STATE OF MAINE  
DEPARTMENT OF TRANSPORTATION  
16 STATE HOUSE STATION  
AUGUSTA, MAINE 04333-0016

April 27, 2021  
Subject: Reconstruction, Marking,  
Lighting & Signing of Taxiways  
State WIN: 020655.03  
Location: **Augusta**  
**Amendment No. 2**

**LIGHTED RUNWAY CLOSURE MARKER**

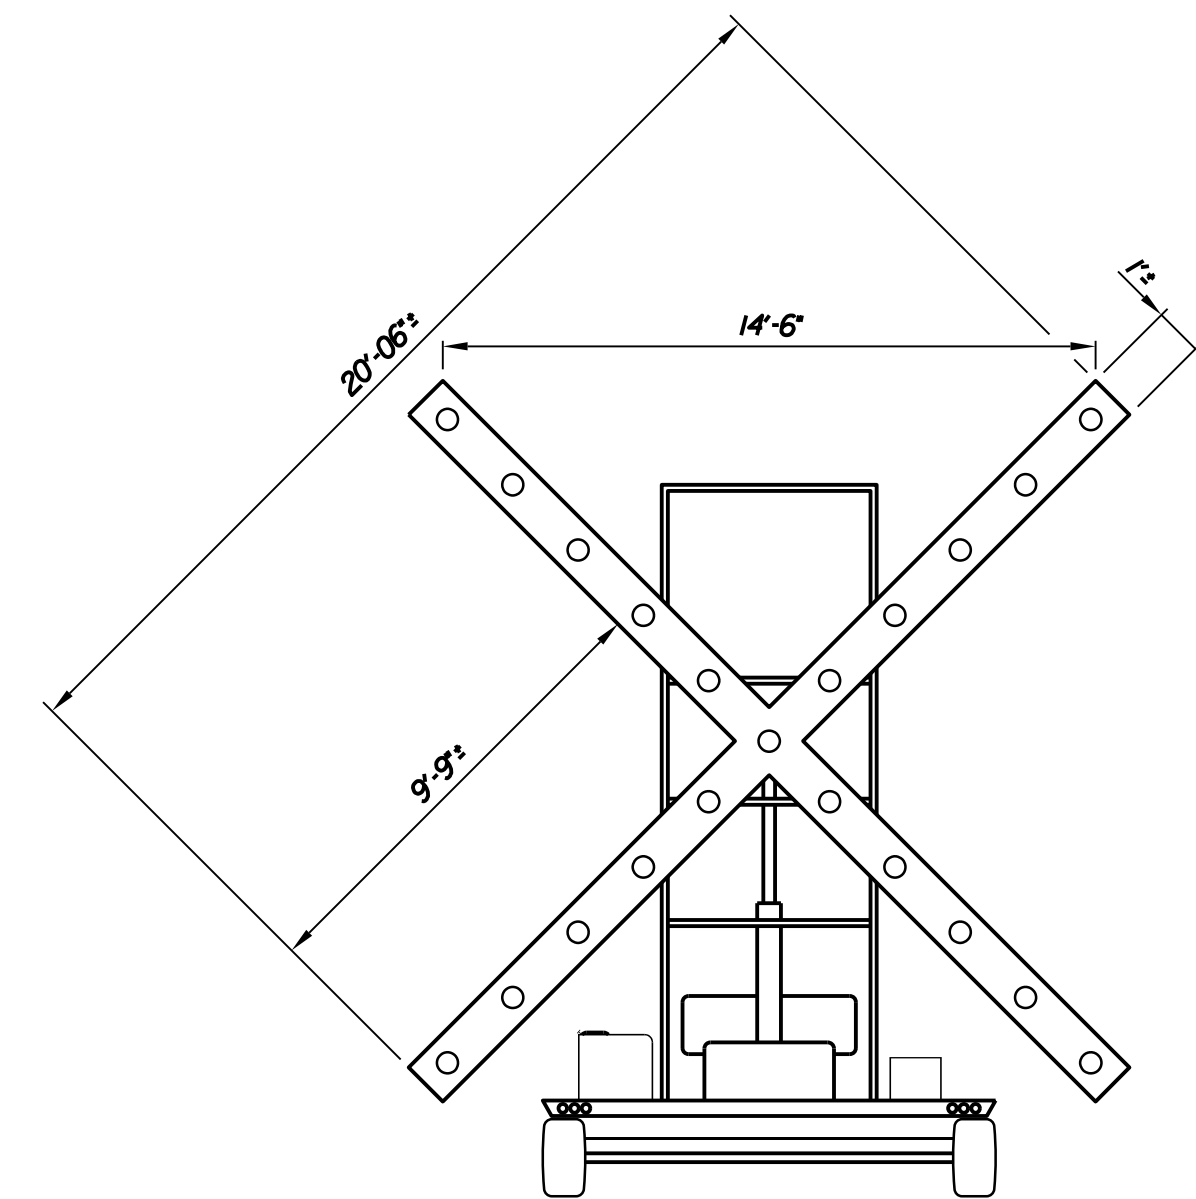
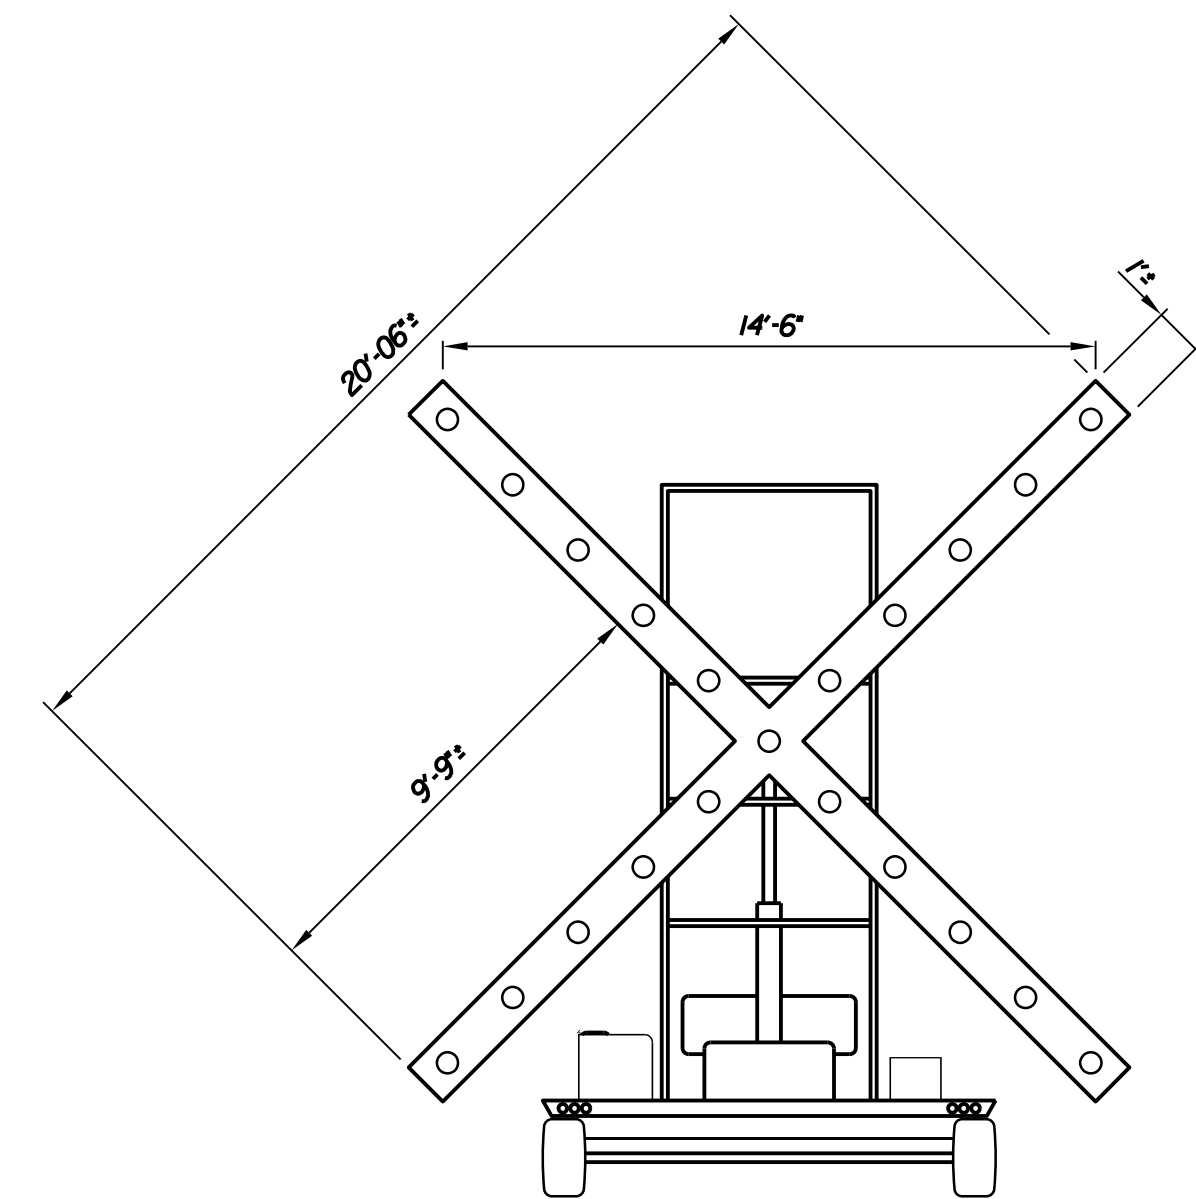
**Question:** Will the Airport be providing lighted Runway Closure markings?

**Response:** Yes, the airport will provide two lighted runway closure markings. The airport will also be providing four (4) fabric closure markings. The Contractor shall set up, operator, maintain and return in good working order.
